INFO-NOTE #P1959

Subject: Change of Blister Tape Dimensions and Quantity per Reel for Type SMS-R000 (ZERO-Ohm Link, Jumper)

Change of Tape Dimensions in Detail

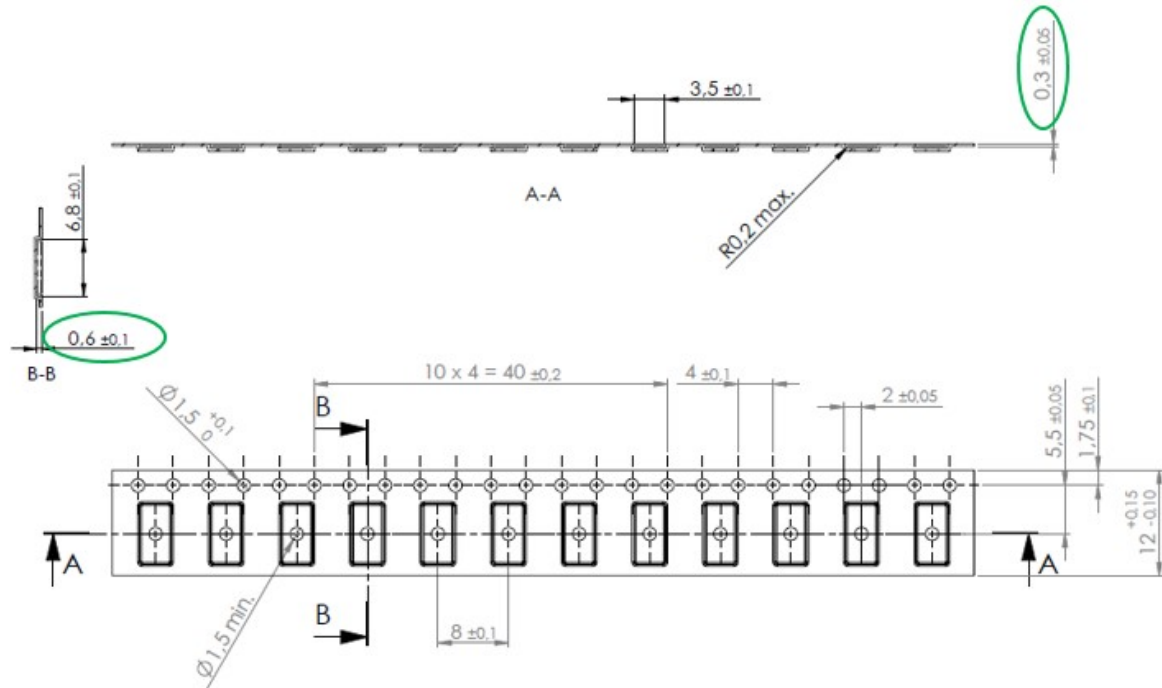
OLD Tape dimensions, according to drawing #Z-YD-655b:

Blister tape material thickness: 0.3mm (± 0.05)

Pocket depth: 0.6mm (± 0.1)

Quantity per Reel: 11,000 pcs.

NEW Tape dimensions, according to drawing #Z-YD-656:

Blister tape material thickness: 0.235mm (± 0.05)

Pocket depth: 0.7mm (± 0.1)

Quantity per Reel: 9,000 pcs.
